# Safety Recall

Mack Trucks Inc.  
Greensboro, NC USA

Date	Number	Release	Page
08.2025	SC0483	01	1(4)

## Mack Command Assist Steering with Oversteer Guidance AN (4), PR (4)

### OTA Programming (Preferred)

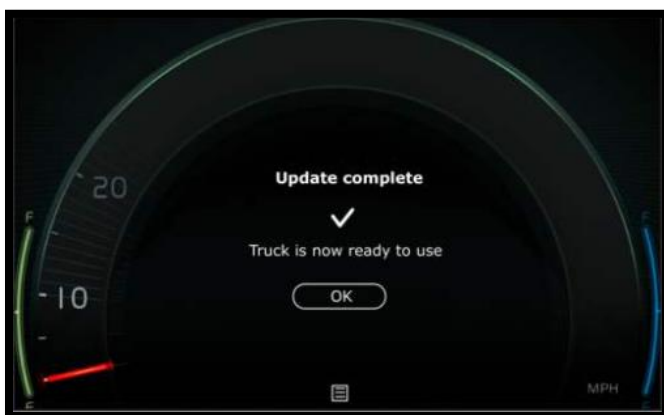
Certain vehicles with Mack command steering and oversteer guidance, may experience an oversteer correction, where oversteer guidance may correct for an oversteer input and then continue to correct in the opposite direction. The resulting oscillations may result in a control issue which requires driver intervention.

In the event of a vehicle oversteer guidance intervention and without driver intervention the on-going correction could result in a crash.

1. Disable the oversteer guidance by programming the truck. Programming can be performed using Over the Air (OTA) or using Premium Tech Tool (PTT).

1. Make sure the truck is outside, park on a level surface, key on engine off, battery sufficiently charged, and parking brake set.
2. Software available should appear in the instrument display.
3. Select to proceed.

4. Software will start updating.
5. Once the software is updated, select ok.

6. Return the truck back to service.
